# Technical Bulletin

Bulletin No: TCH-001-056

Subject: **New Gasket for Bendix® Inlet Check Valves (ICVs) Used for BA-921™ Compressors (Detroit Diesel Applications)**

**FIGURE 2 - New Components**

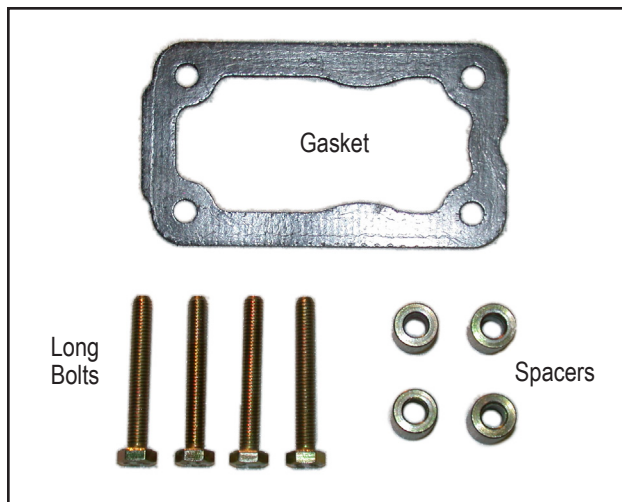
All new orders for service replacement ICV assemblies will feature the new gasket, spacers and longer bolts.

**FIGURE 1 - Comparison Showing New Gasket**

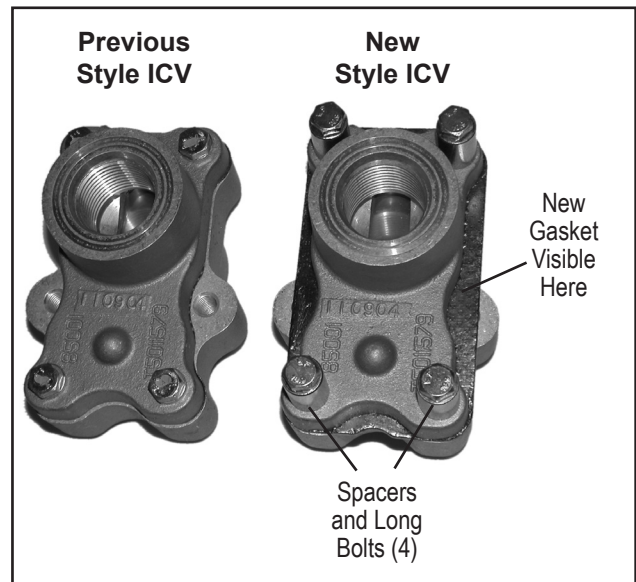
As a product improvement for the Bendix Inlet Check Valves (ICVs) used for BA-921™ compressors, Bendix is now implementing a new gasket design and material as a running change in all assemblies and kits.
